***STATE SIGNIFICANT DEVELOPMENT
ASSESSMENT REPORT:
Hornsby Ku-ring-gai Hospital
Redevelopment Stage 1
Palmerston Road, Hornsby
(SSD 5356)***

Director-General's
Environmental Assessment Report
Section 89H of the
Environmental Planning and Assessment Act 1979

May 2013

Figure 5: Southern Elevation (view from Burdett Street)

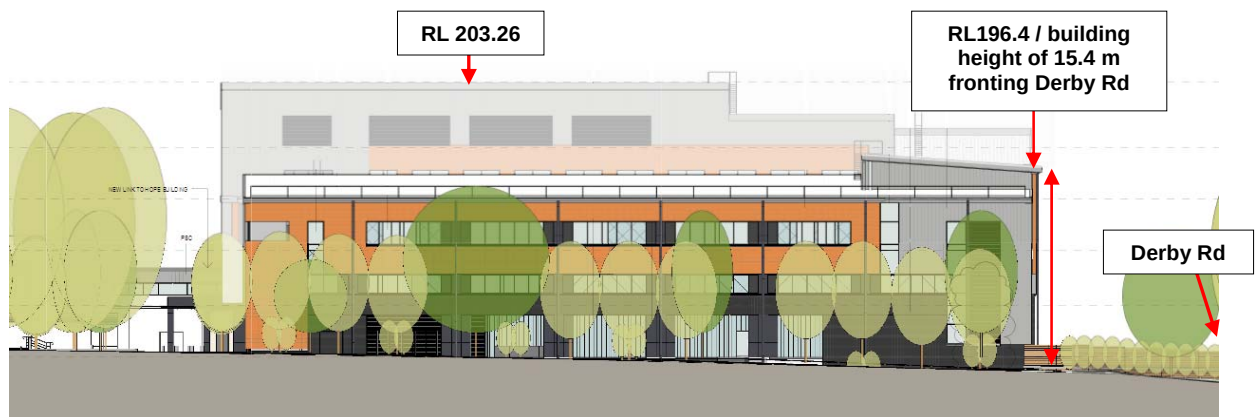
During assessment of the application, the department raised concern with the 2.7 metre setback from the southern Burdett Street boundary, as the height of the building in this location is 12.9 metres above existing ground level, which is significantly higher than existing low density residential development opposite the site. The setback also does not facilitate an adequate deep soil zone to allow vegetation of an appropriate scale to provide appropriate screening of a building of this size. The department requested that the applicant provide a greater setback along with an increased deep soil zone, in collaboration with additional plantings of mature vegetation to provide appropriate screening along Burdett Street.

Notwithstanding, the applicant made modifications within the setback to the Burdett Street boundary to provide further capacity for mature vegetation and landscape screening of the building. The modifications included narrowing the concrete maintenance path along the buildings edge and supplementing the existing street trees which grow on the council verge with plantings of *Tristanopsis laurina* (Water Gum) within the setback. The additional trees are to be planted at regular intervals and will grow to a height of 6 metres and have a canopy spread of 4 to 6 metres, and are intended to provide year-round visual screening of the southern façade of the building.

The garden bed between the building and the existing street footpath was also increased slightly and varies in width between 1.74 and 1.95 metres, which takes greater advantage of the deep soil area and allows for more varied planting with a combination of groundcover, grasses, and shrubs to create a layered effect when viewed from Burdett Street.
